AXC F 2152 – CHANGE NOTES

Change notes for the AXC F 2152 controller

108427_en_51

This document contains all changes made between firmware version 1.0.0 and the current firmware version of the AXC F 2152 controller (item no. 2404267).

Left-alignable INTERBUS master

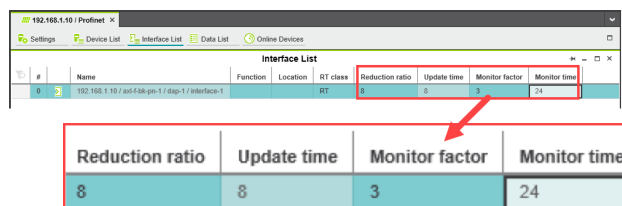
The controller now supports left-alignment of the INTERBUS AXC F XT IB master (Order No. 2403018).

Figure 2 Select Trigger task

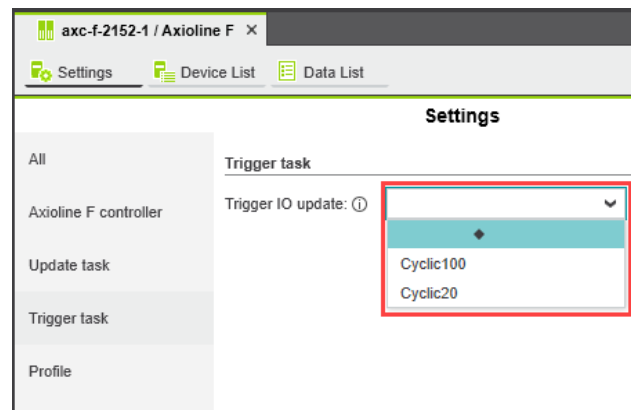
- Select the “Trigger task” view in the “Settings” editor.
- In the drop-down list, select the task that is to trigger the Axioline F I/O data update.

If you do not select a task, the update will occur by default every 50 ms.
